Crete Nursery, Dappers Lane, Angmering, West Sussex

Arboricultural Method Statement ADDENDUM

Site Reference: EE-19-10250-01

Plate 2: Garden & Boundary Fences

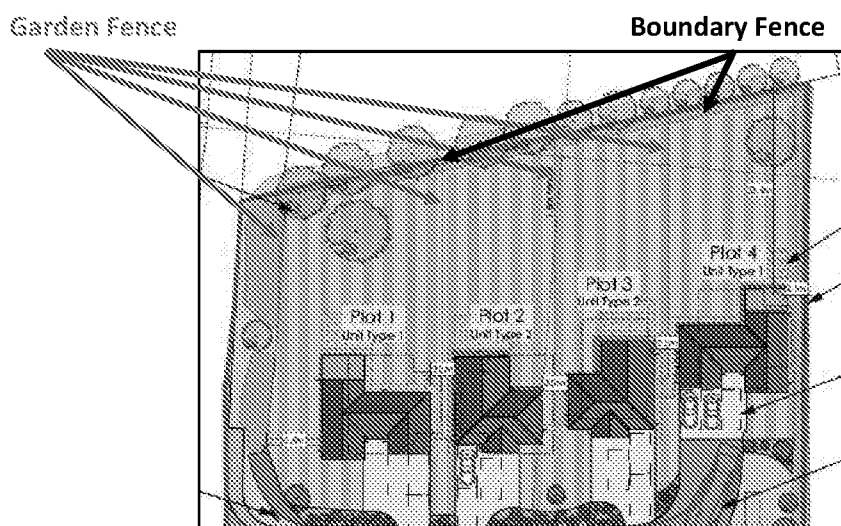
- 1.4 Paragraph 3 states *'The AMS does not cover in enough detail what is happening with the boundary fencing and garden division fencing within the RPA of the hornbeam trees to the north and off-site – mitigation measures and methodology required here.'*

- 2.2 The development proposals require the construction of small fences (1.8m high) to delineate the gardens of each plot and the northern boundary of the site (see Plate 2). The boundary and garden fence will be comprised of closeboard panels and posts, the posts will require digging within the RPA of the hornbeams.

- 2.4 The garden fence (see Plate 2) will be constructed using 1.8-metre-wide panels with supporting fence posts. This will require digging a maximum of three fence posts per fence line to be dug within the RPA of the line of hornbeam to the north of the site. The holes for the fence posts will measure L: 0.2m x W: 0.2m x D: 0.5m – the holes will be lined with a series of plastic sheets to ensure damaging leachate from the concrete block base does not enter the RPA of the hornbeams.

- 2.6 Within the RPA, the holes for fence posts will be dug using hand tools only; specific fence digging equipment is appropriate.
- 2.7 The depth of the holes for the fence posts will measure 0.5m deep and 0.2m x 0.2m wide. The fence post will be held in place using either post mix or ballast and cement.

- 2.8 The erection of each post, from digging the hole to setting the post, will be completed in one go to avoid having roots exposed overnight.
- 2.9 The boundary fence will be placed over the existing wooden fence that marks the northern boundary of the site using the location of existing posts as the support network for the new fence.

- 2.10 The holes for the fence posts will be lined with a series of plastic sheets to ensure damaging leachate from the concrete block base does not enter the RPA of the hornbeams. The series of plastic sheets will be comprised of an initial layer of thin sticky plastic, akin to carpet protector, that will be rolled around the outside of the hole to create an impermeable layer. Two narrow sheets of thicker polythene sheeting will then be laid in a crisscross fashion over the bottom of the fence post as it is inserted into the hole to create extra protection from leachate and to ensure the thinner outer layer is not perforated in the act of inserting the fence post.

Plate 4: RPA of T07 in Relation to the Existing Hardstanding Access Track
Dominant Category A Oak Tree (T07) With 9.15m RPA Superimposed

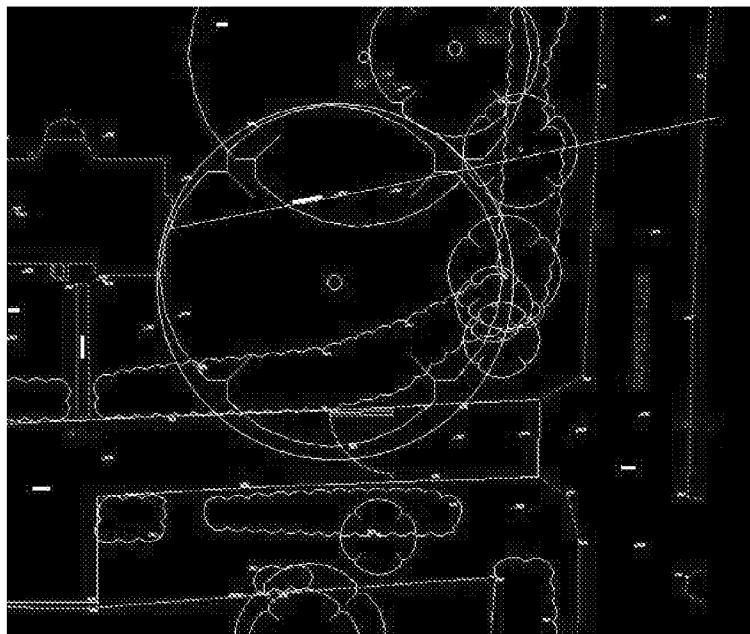
- 1.5 Paragraph 4 states that *'The AMS does not detail exactly what is happening and the mitigation measures and methodology required here for any revisions to the access drive (widening or resurfacing) that appear to be taking place.'*

- 3.2 The removal of the existing hardstanding track will be undertaken using the '*break up, pull back*' principle. The pieces of concrete will be taken out by hand and placed outside of the area of concern. The subbase will be taken out using a mini digger stationed on the remaining hardstanding to ensure roots do not become compacted.

- 3.3 The area exposed will be protected and cordoned off, using tree protective fencing (*if necessary*), between the time that the existing hardstanding is removed and the replacement permeable hardstanding is implemented.

- 3.4 A subbase of appropriate depth and durability will be laid underneath the replacement permeable paving to ensure that roots do not become compacted and water can percolate to the roots over the long term.

- 3.5 The southern extent of the replacement road will follow the line of the existing track and will not extend further toward the dominant Category A oak (T07).

- 3.6 The RPA of T07 (9.14m) will be measured and marked-out using fluorescent spray paint, where it extends underneath the existing hardstanding access track, to identify the area of concern to all site users. This will be undertaken at the earliest possible convenience following full planning permission being granted. The marked-out area will conform broadly to that highlighted in the bottom picture of Plate 4. The line will be suitably annotated to clearly signify what it is marking out, the hardstanding outside of this line can be removed without the supervision of an arboricultural watching brief.

- 3.7 The existing hardstanding access track will be removed by breaking apart the concrete using hand tools, such as a pneumatic drill (jackhammer), under the supervision of an arboricultural watching brief. The concrete will be retrieved by hand from the existing hardstanding, where possible, and from scaffold boards laid out to protect roots, where not possible. The pieces of concrete will be placed within the site outside of the contentious areas, the subbase will be removed with a mini digger, from the remaining hardstanding, using the '*pull back*' technique and under supervision of the arboricultural watching brief.

- 3.8 The soil exposed from underneath the removed hardstanding will be covered, using a tarpaulin and weighed down / buffered from weather using sharp sand or another inert granular fill (not builder's sand because of its high salt content) to protect the roots from desiccation and rapid temperature changes. The area will be also be cordoned off using tree protection fence, if necessary, and all site access will be excluded from the area until the construction of the replacement permeable hardstanding access track is started.
